UNITED STATES PATENT AND TRADEMARK OFFICE

APPLICATION NO.	FILING DATE	FIRST NAMED INVENTOR	ATTORNEY DOCKET NO.	CONFIRMATION NO.
10/783,162	02/20/2004	Wade D. Vinson	200400249-1	7167

Office Action Summary	Application No. 10/783,162	Applicant(s) VINSON ET AL.	
	Examiner Vikansha S. Dwivedi	Art Unit 3746

DETAILED ACTION

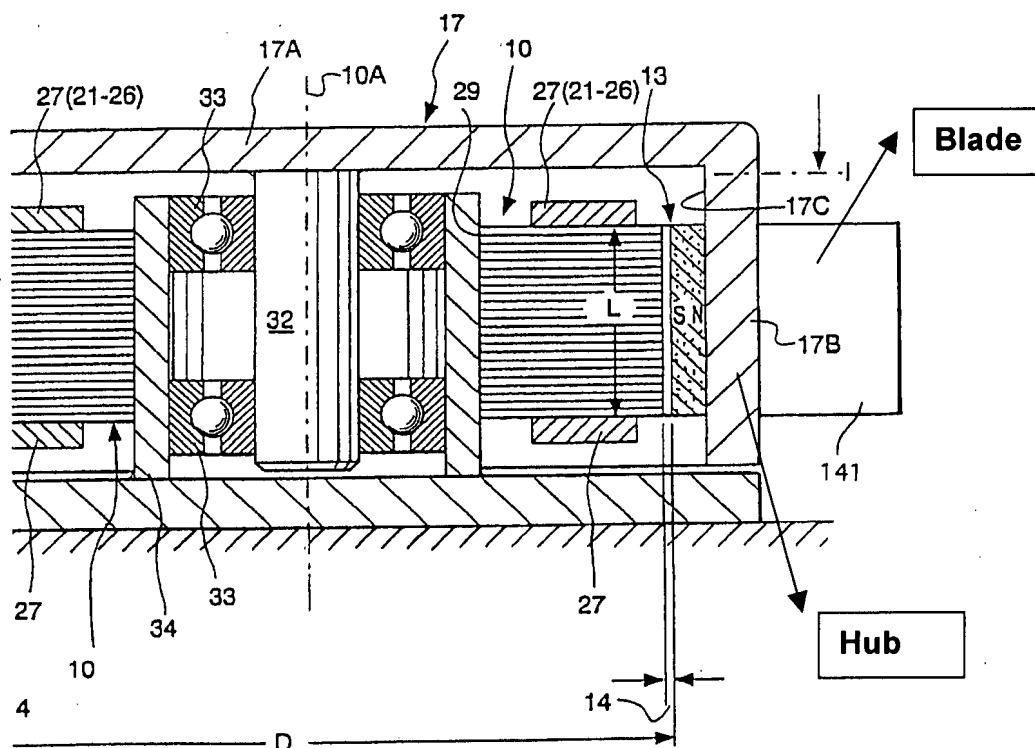
Von der Heide teaches a cooling fan comprising: a three-phase DC motor, an impeller comprising a hub to house said motor and a plurality of blades 141 extending from the hub. It should be clear rotor housing 17 is the hub and has plurality of blades 139 and 141 extending from the hub 17. for applicant's convenience the hub and the Blade are shown below. It is a marked up copy of Von der Heide figure 2.

It should be clear that a impeller is the rotating part that transmits motion in a device such as a cooling fan. In case of Von der Heide a magnetic external rotor comprises an inverted cup-shaped rotor housing/hub 17 with a horizontal top surface 17A and a cylindrical circumferential wall 17B that supports the blades 139 and 141. Stub shaft 32 is attached to the center of rotor housing 17 at the center of top 17A. Stub shaft 32 rides in ball bearing journals 33 and is supported thereby in a manner that rotor housing 17 is pivotally secured to stator 10 and can rotate about center axis 10A.
